Addendum  
to the  
Initial Study/Mitigated Negative Declaration  
for the El Dorado County  
Western Slope Animal Shelter  
(SCH #2006092070)

Relocation of Access Road Alignment

El Dorado County, California

July 2011

FIGURE 1

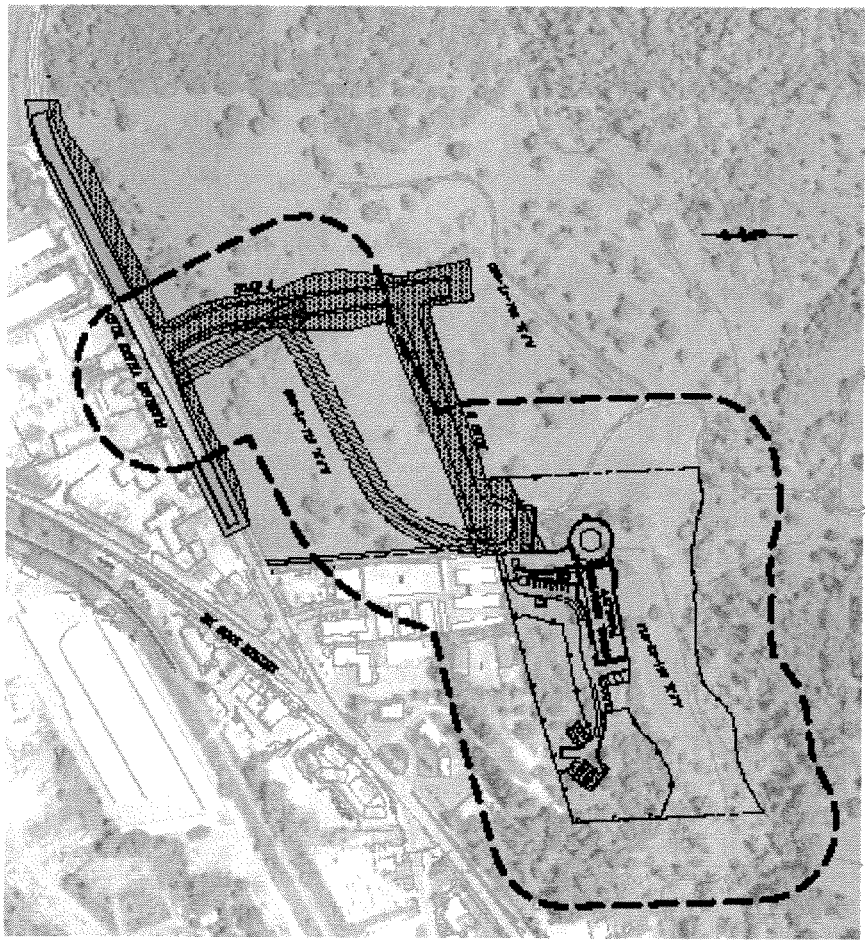
On July 20, 2010, the Board of Supervisors directed DOT staff to return to the Board to re-establish the location of the access road to help accommodate surrounding land uses. The original project need, objectives, location, and existing environmental setting have not changed. As directed, DOT realigned the access road eastward resulting in a slight expansion of the original project area than originally analyzed. Figure 1 demonstrates the revised location of the access road compared to the original location, as well as the slight expansion of the temporary construction road easement, slope and drainage easements. This expanded project area also includes the encroachment necessary for access onto Pleasant Valley Road, pursuant to County encroachment standards, that was not within the 2006 IS/MND Project Description.

As shown on Figure 1, Road A extends from Pleasant Valley Road south to a hammerhead turnaround and to Road B. Road B turns eastward from Road A and ends in a cul-de-sac at the Animal Shelter property. Road A is proposed to be 40-feet wide and Road B is 36 feet.
